**COLLEGE OF DUPAGE
REGULAR BOARD MEETING**

McAninch Arts Center (MAC) 153 Classroom Renovation Project General Contractor

This addendum is being issued to update the specifications and provide additional information.

EXHIBIT A – QUESTIONS AND ANSWERS

2 MAC RM EAST ELEVATION
1/4" = 1'-0"

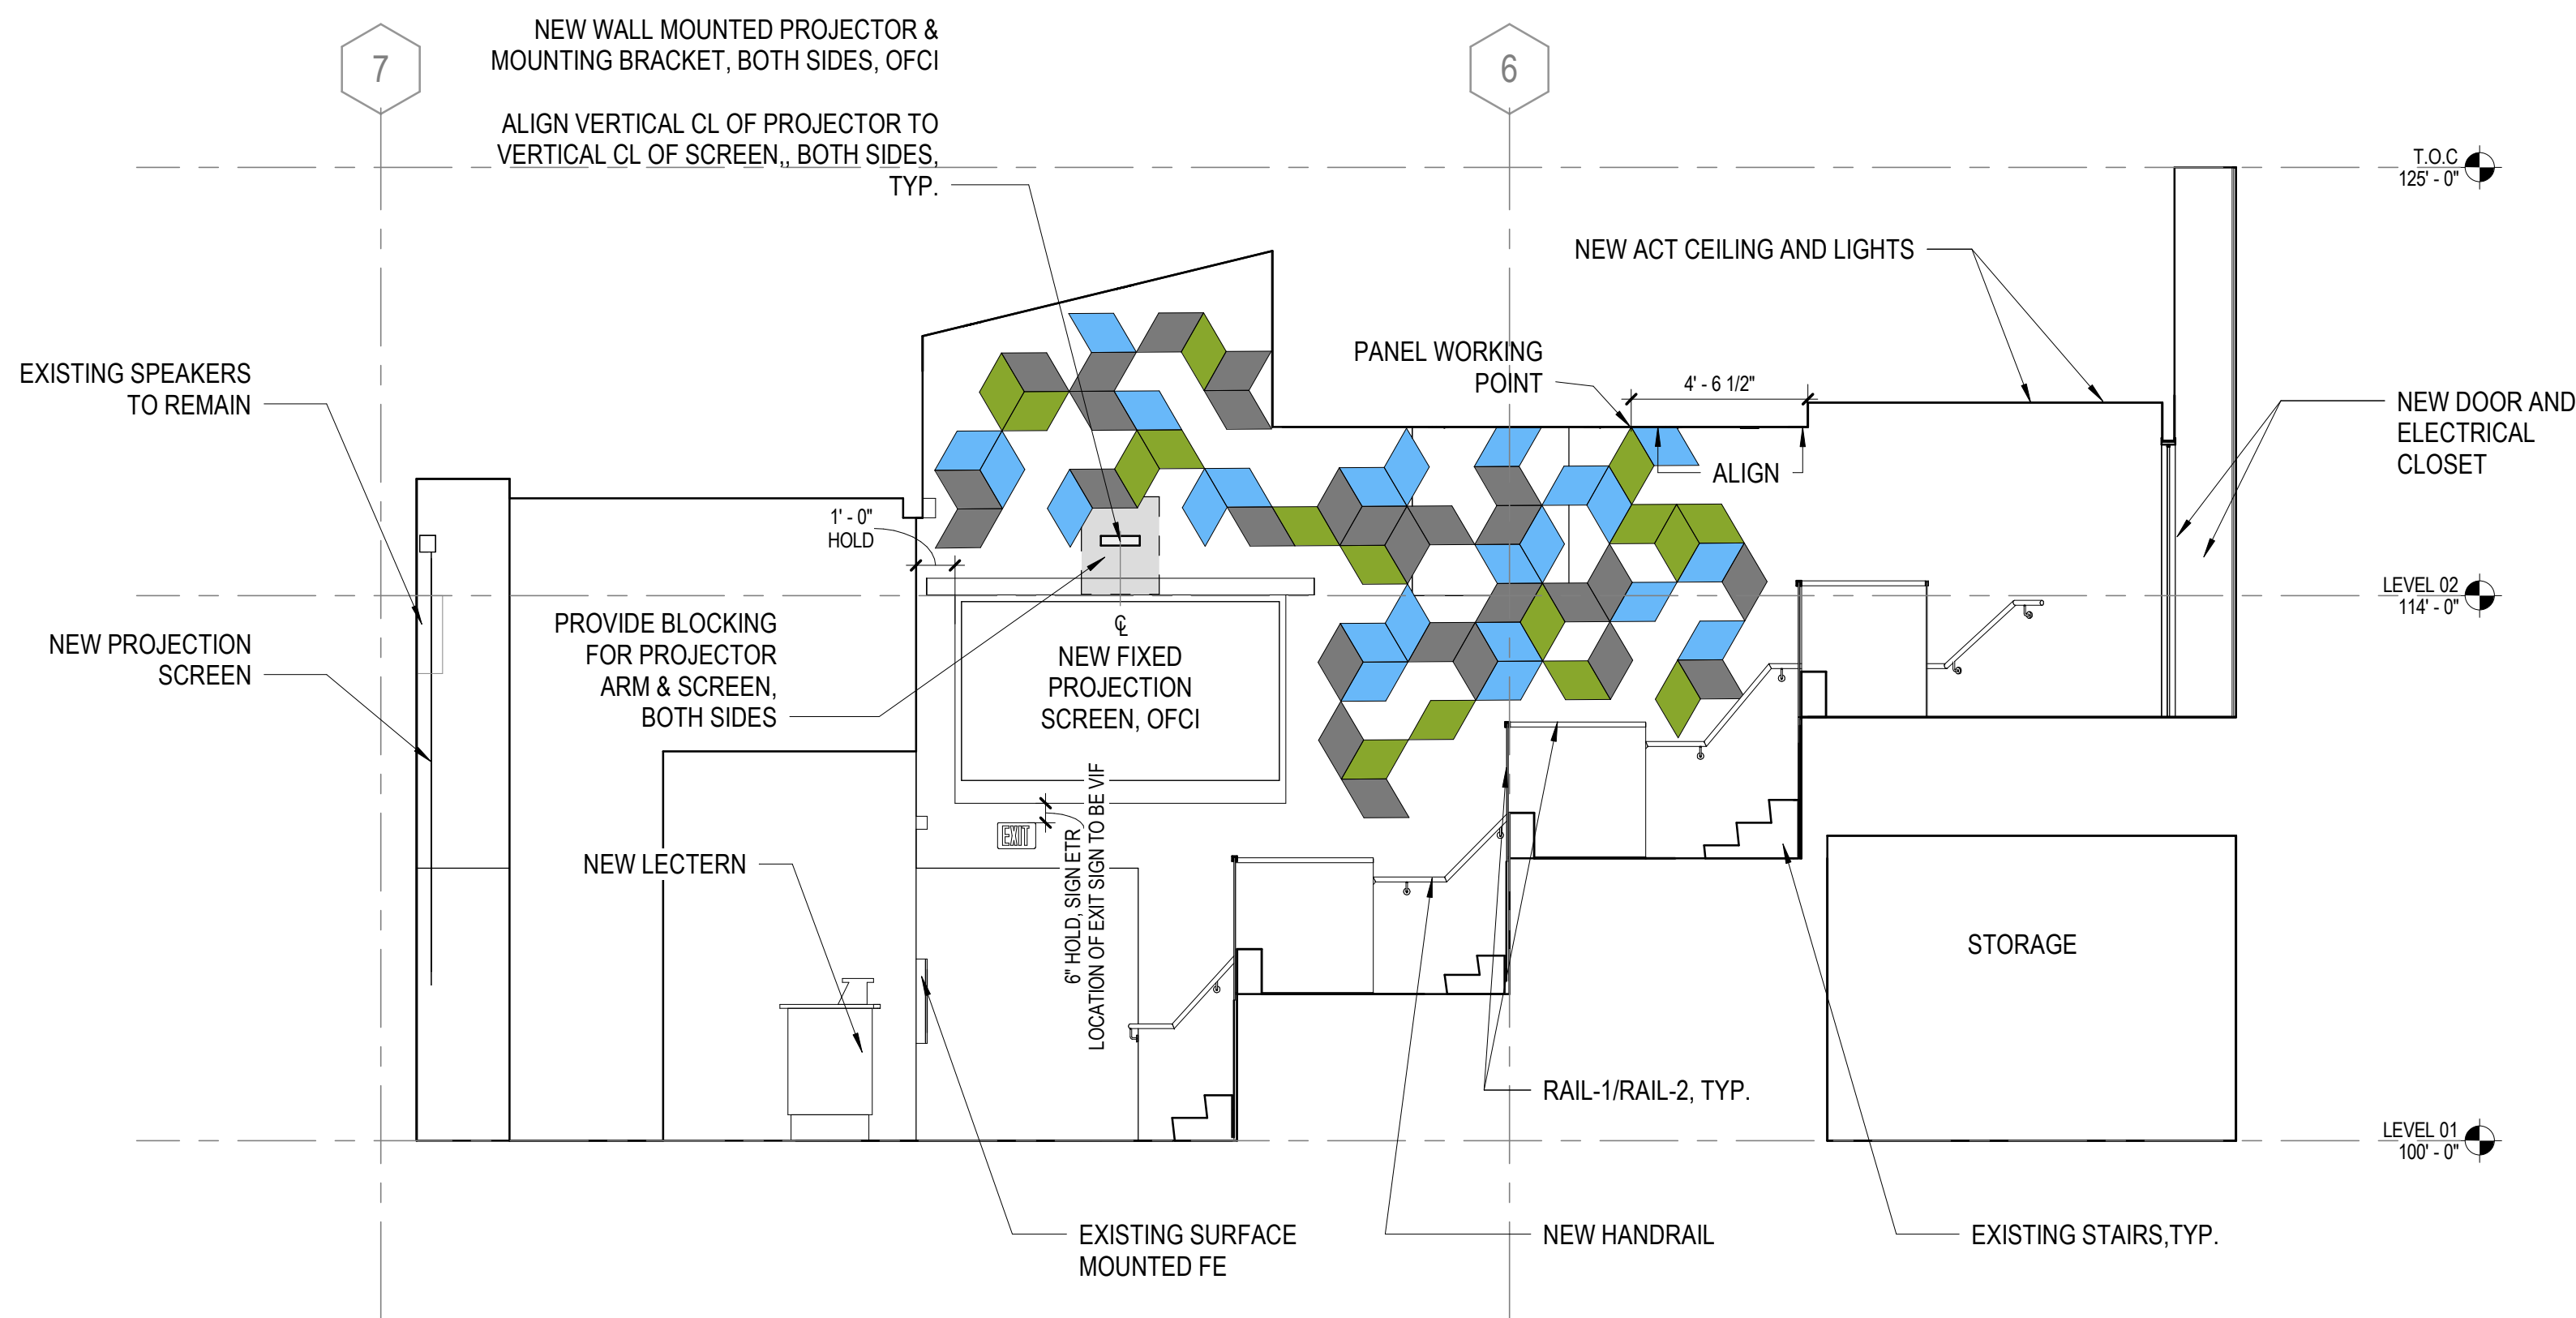
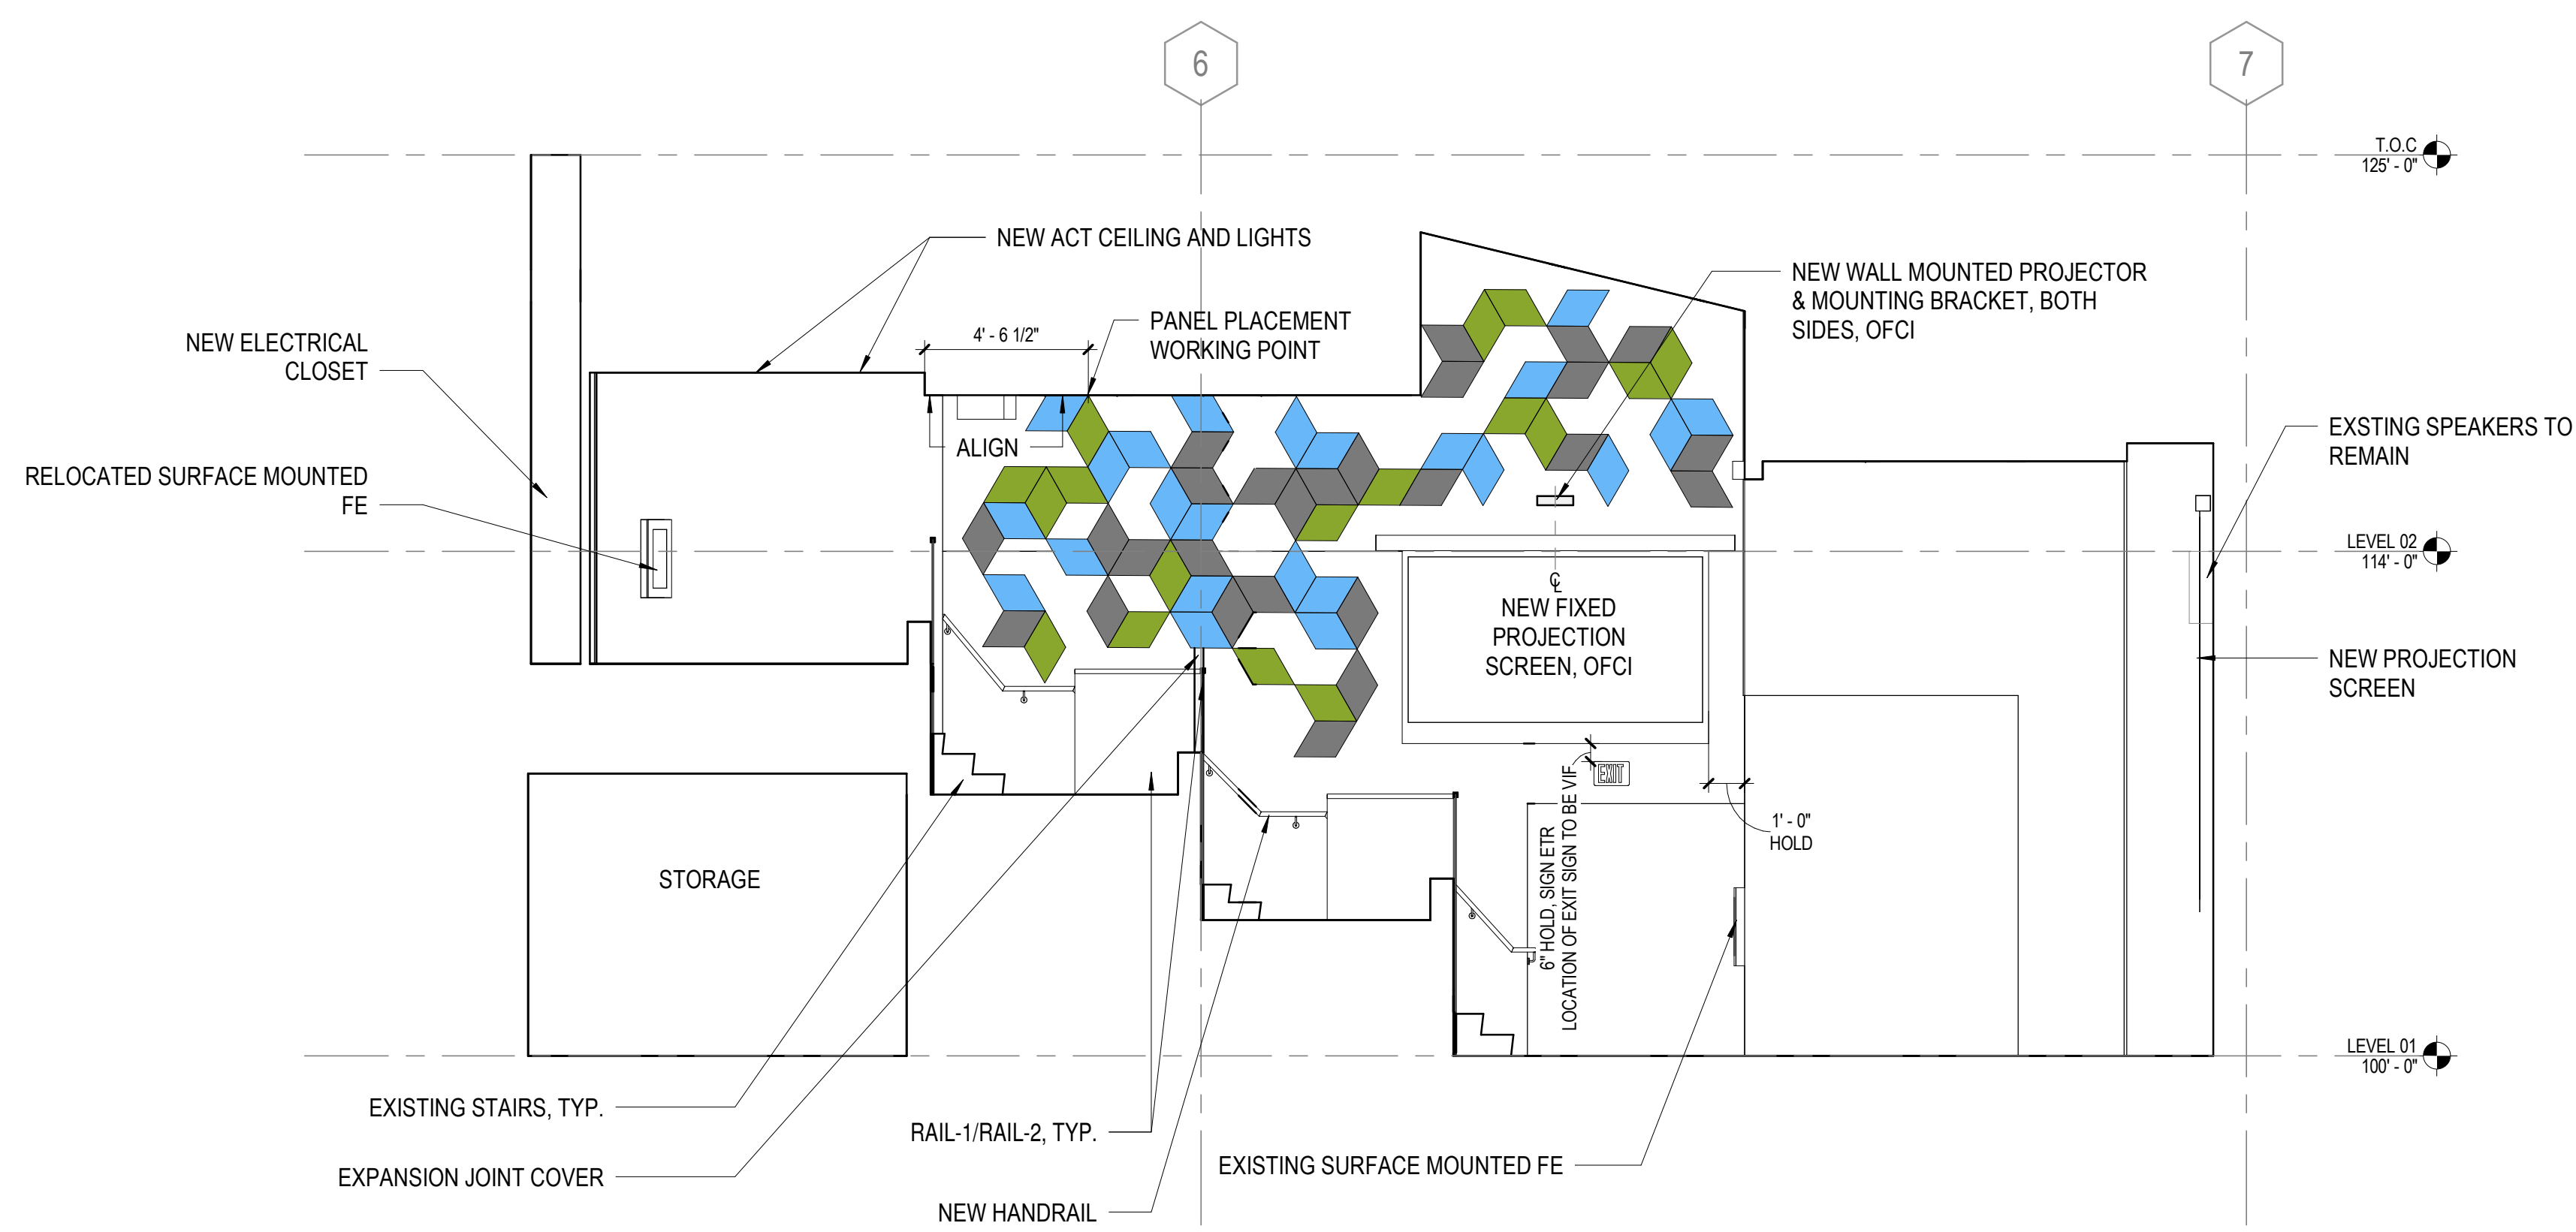
Q3 – Please Provide Room Finish Schedule with the type of flooring used where, as well as the wall covering and paint and base.

A3 – The finishes in the room are described in the drawing tag on 2/!5-01 along with the legend below that drawing. RB-2 is described on 8/A44-01. Wall panels are noted on A44-02.
